Addendum No. 1
May 21, 2024

Project: Harrisburg Softball / Baseball Complex
Harrisburg, South Dakota
Architecture Incorporated Project #2822

Architect: Architecture Incorporated

2.40

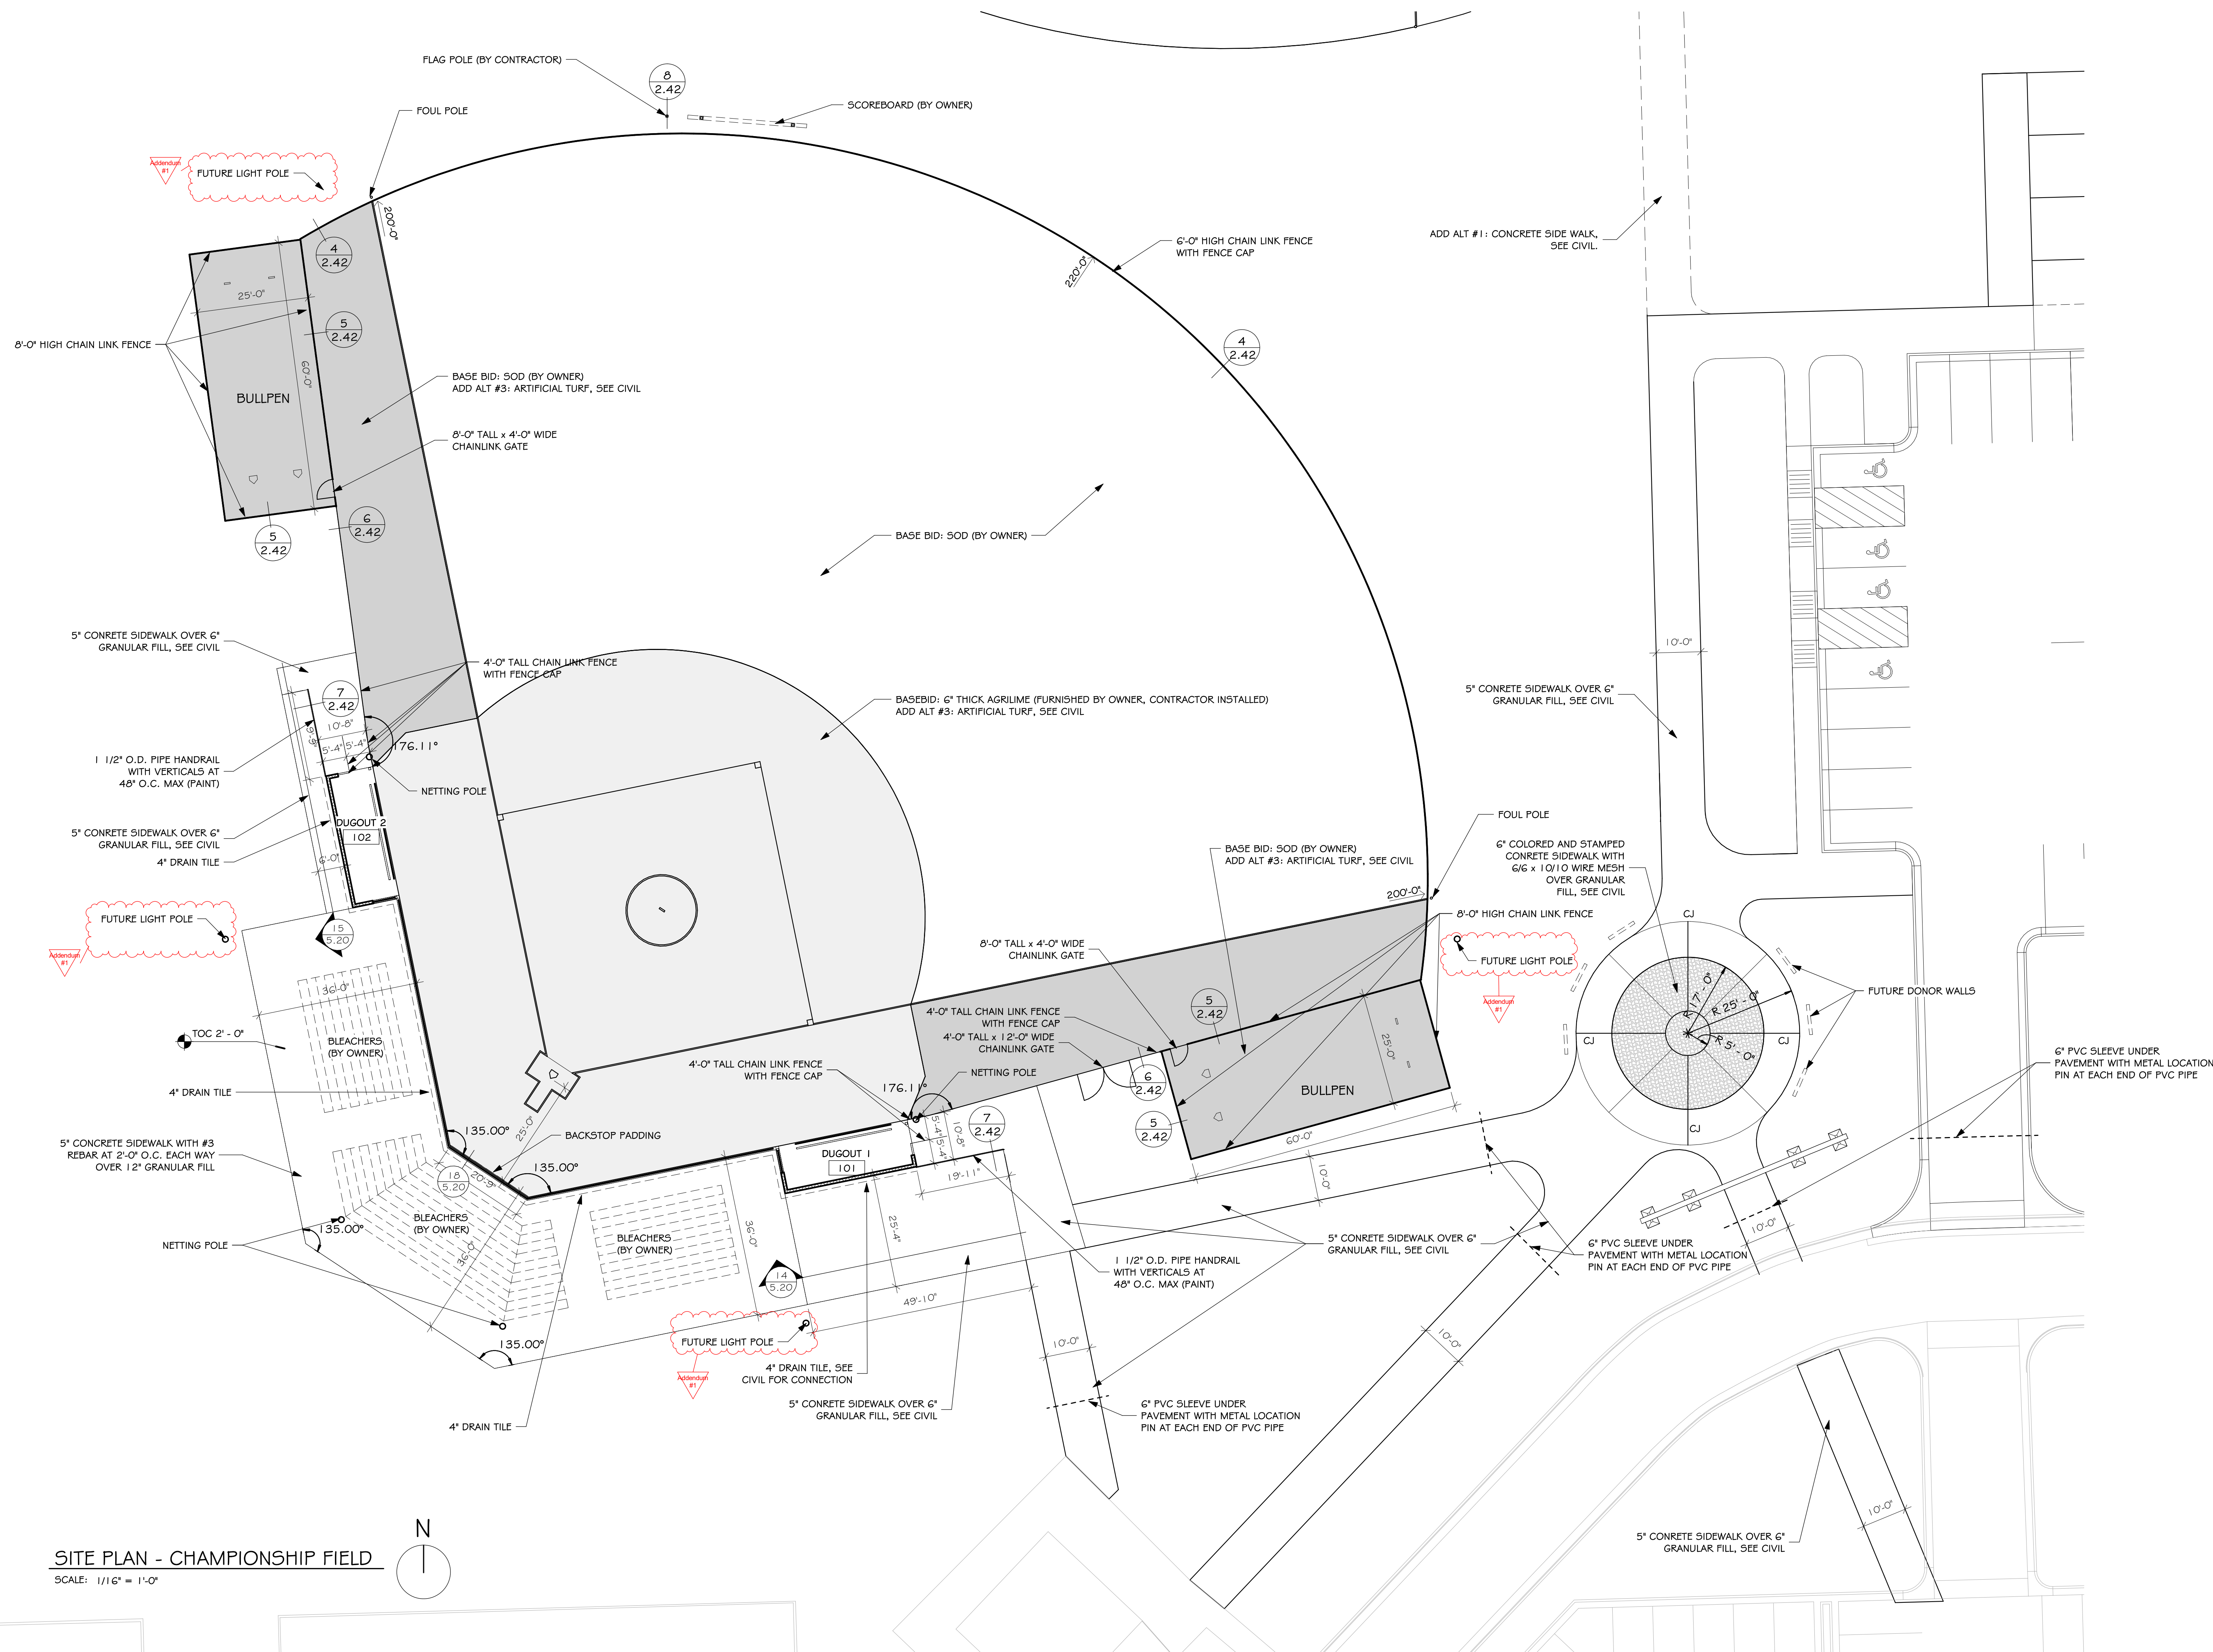
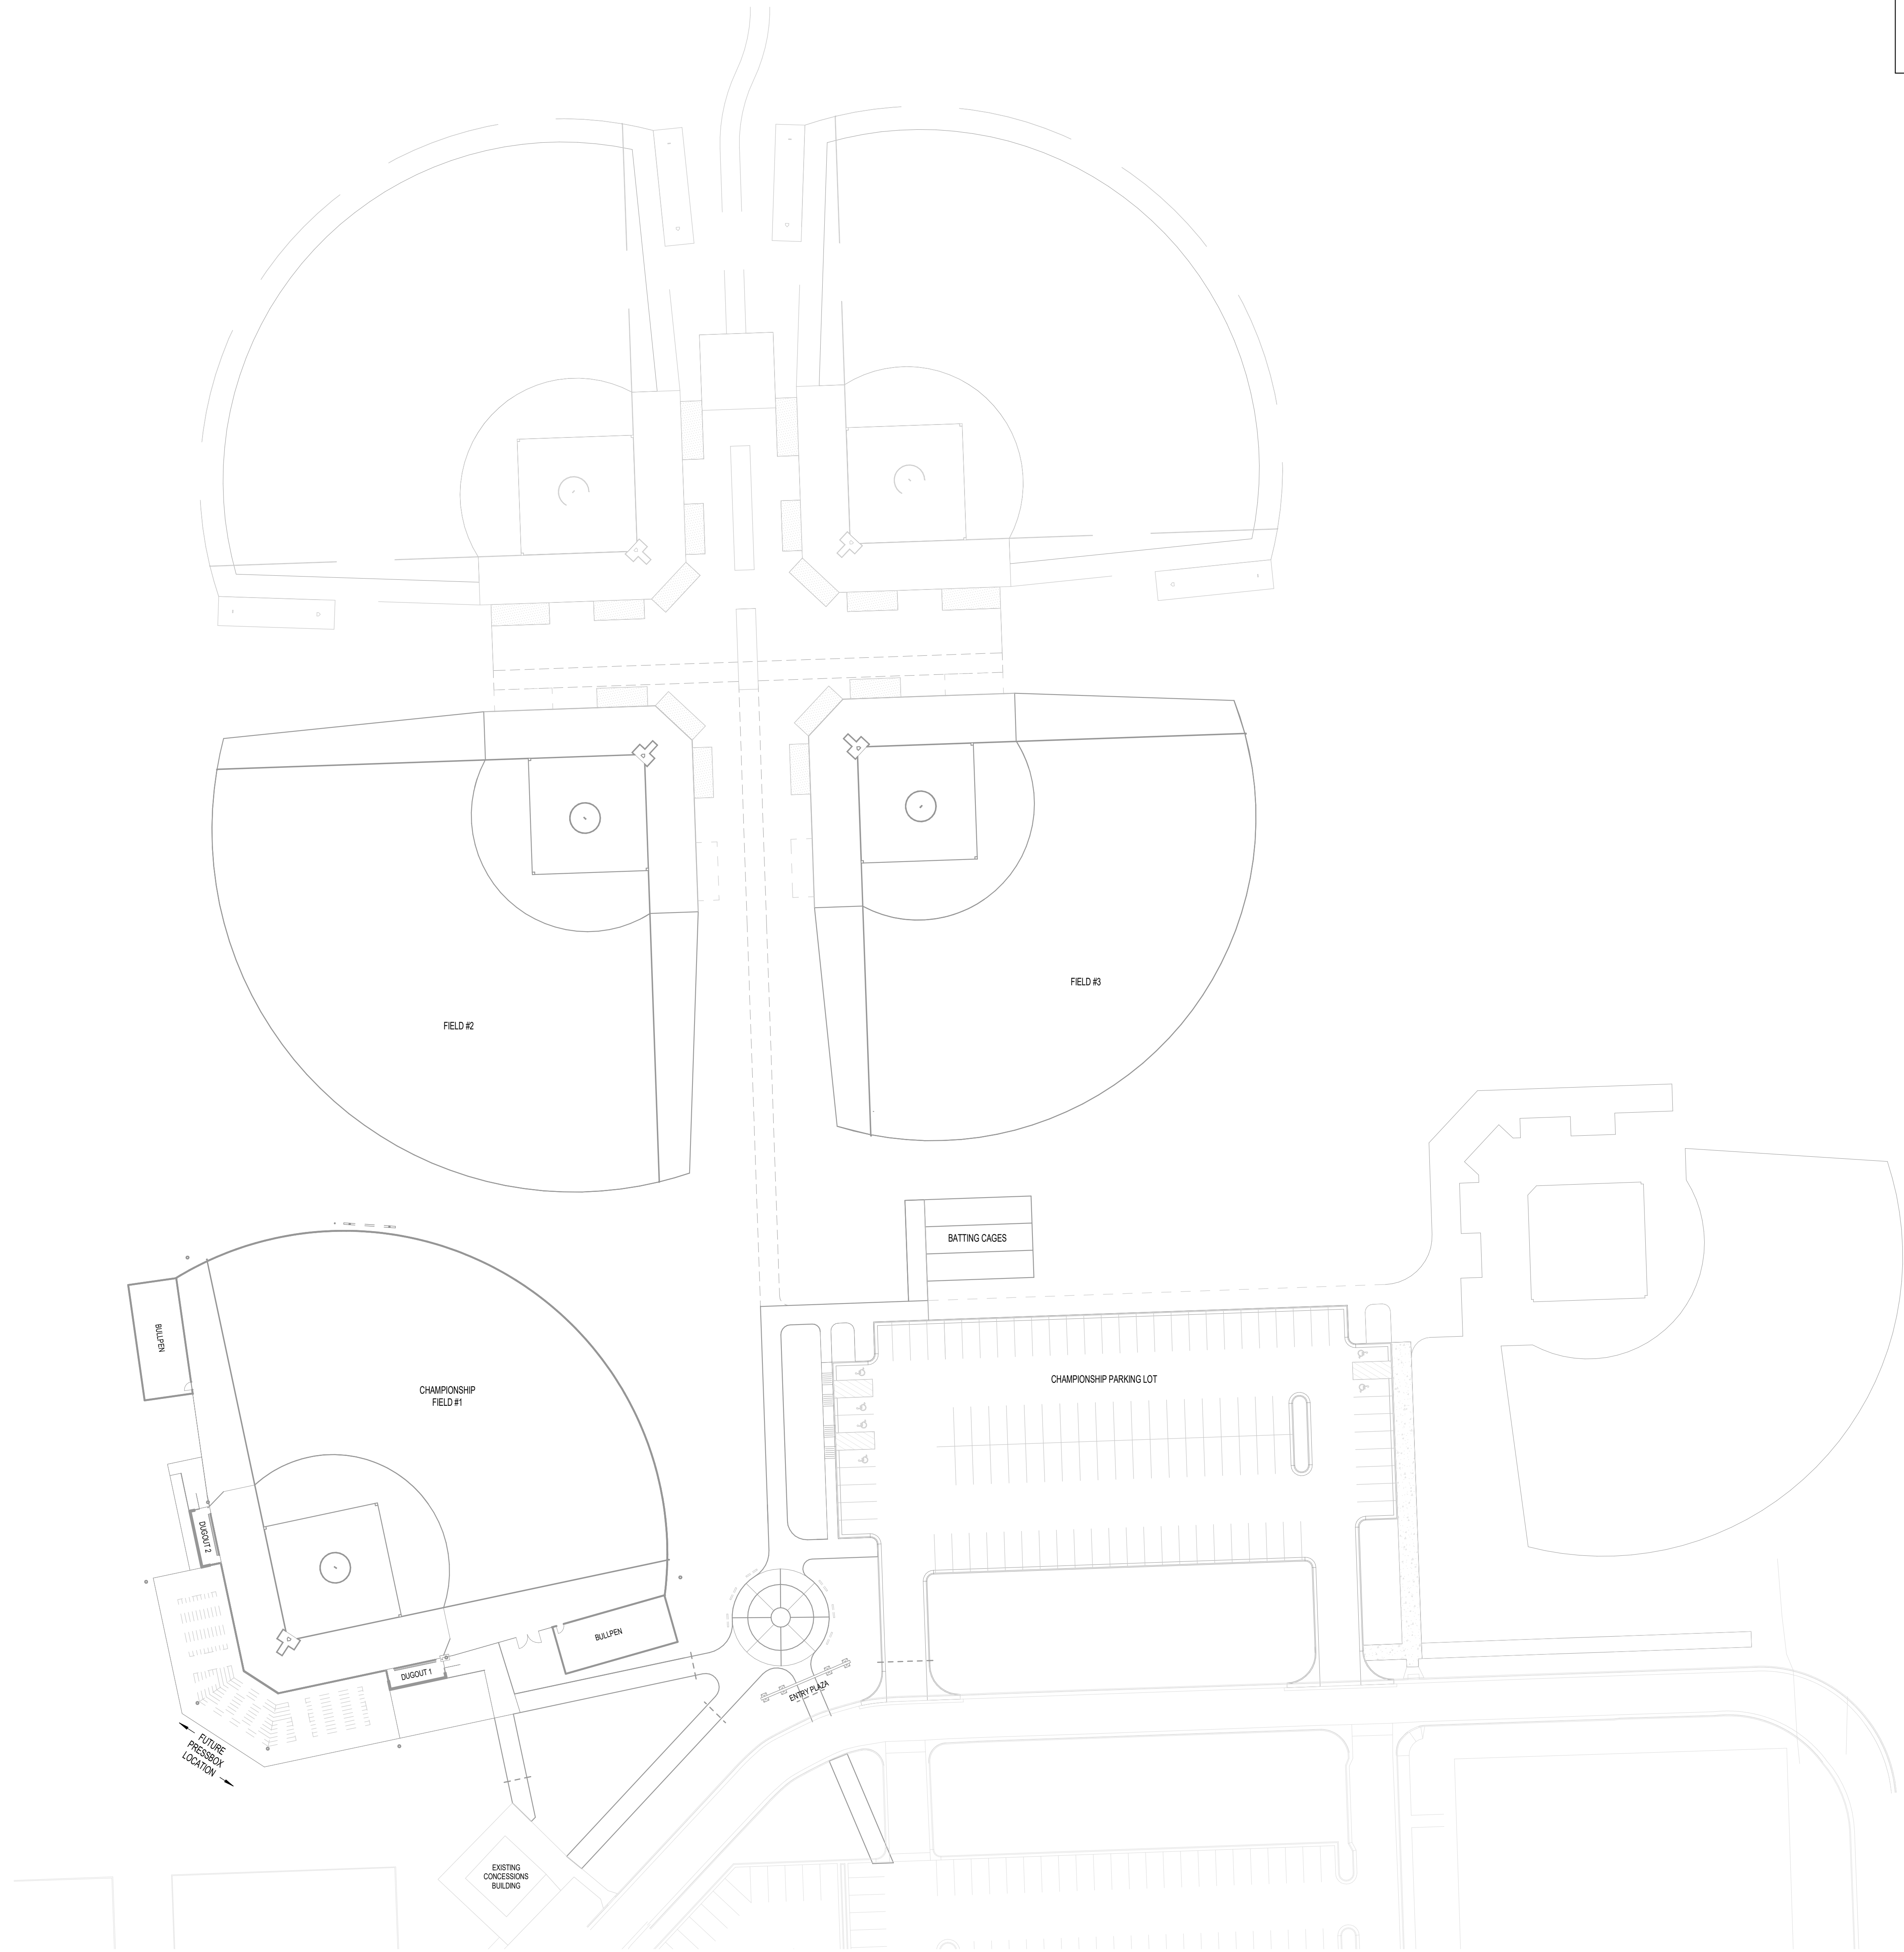
5) SHEET 2.40 – ARCHITECTURAL SITE PLAN

- a) Reference *revised* drawing Sheet 2.40 (revision dated 5-17-24) attached to the end of this addendum for adjustment of future light pole locations.
